Planning Commission
October 15, 2024 - 6:00 PM
233 South Main Street, Monroe, Ohio

DATE: October 15, 2024
RE: Information Packet for October 15, 2024 Planning Commission Meeting at 6:00 p.m.

I. Case No. 2024-10-6— Public Hearing—Consideration of a Conditional Use Permit for the expansion of Monroe First Church of God

A2.1

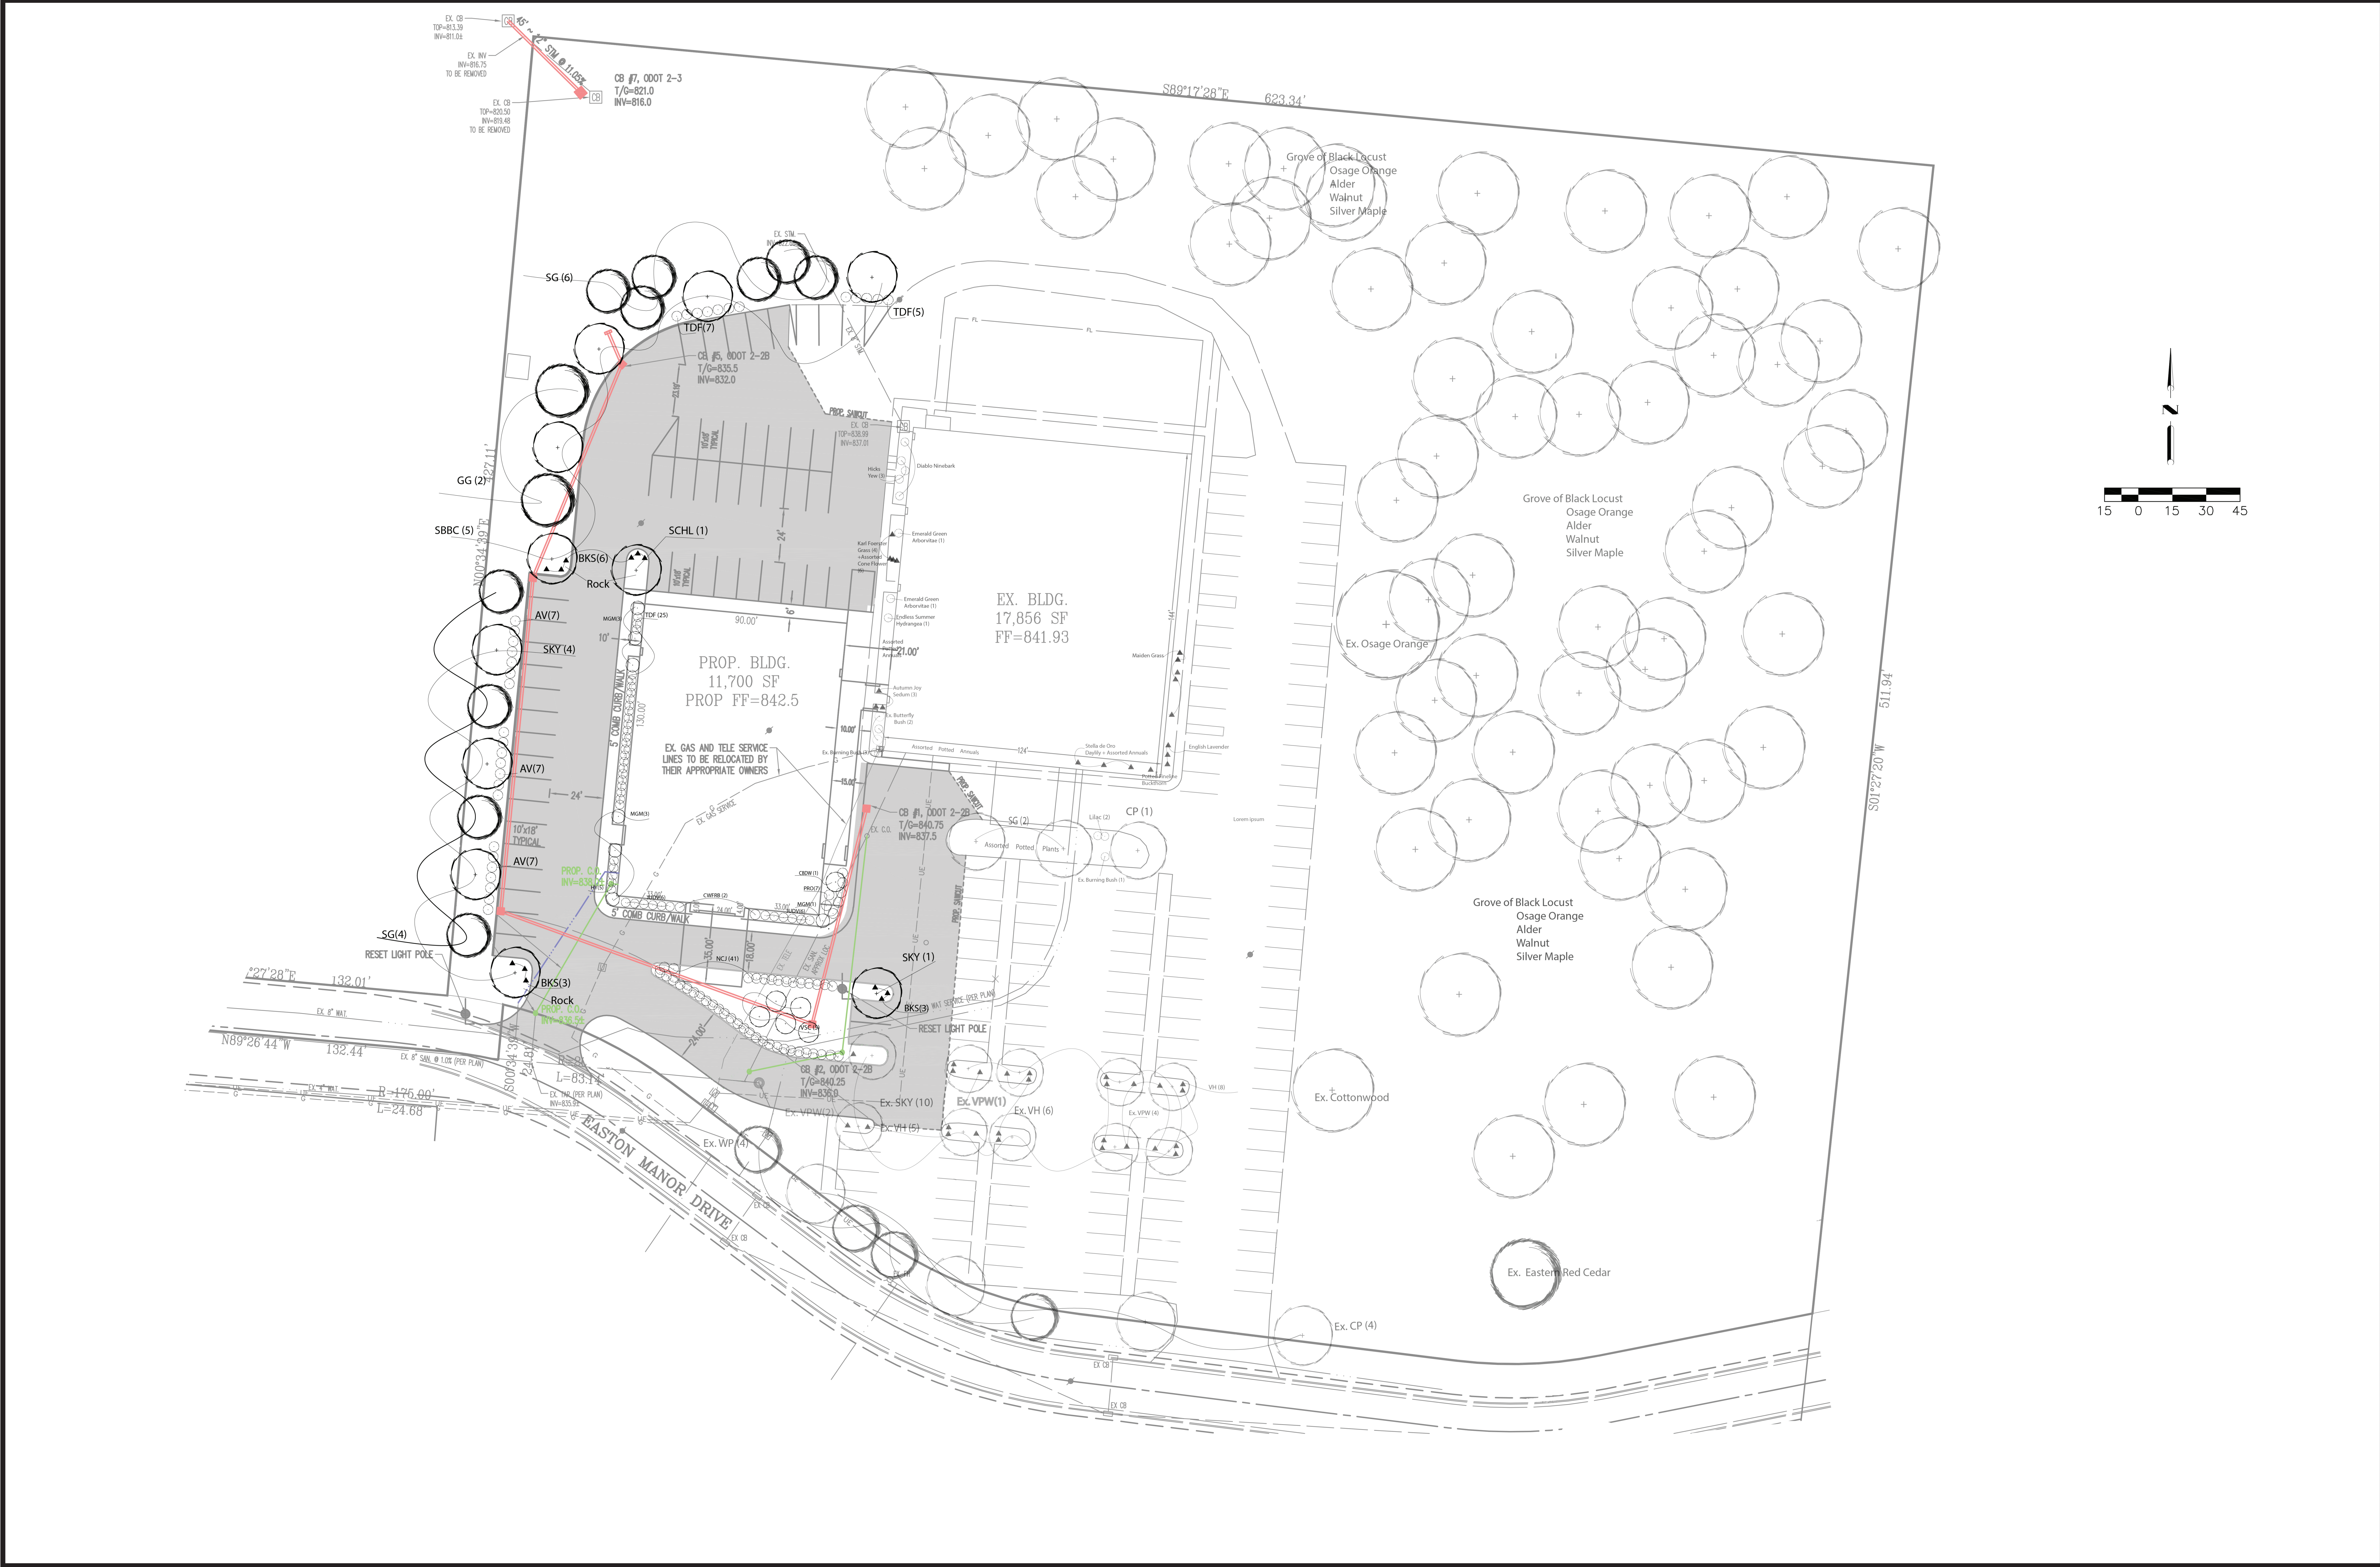
1. Only 20% of each window area may be opaque or spandrel glass.
 - The elevations refer to tinted glass, which the applicant has clarified will be clear. Revised elevations will need to be submitted with the correct labeling the window material callouts.
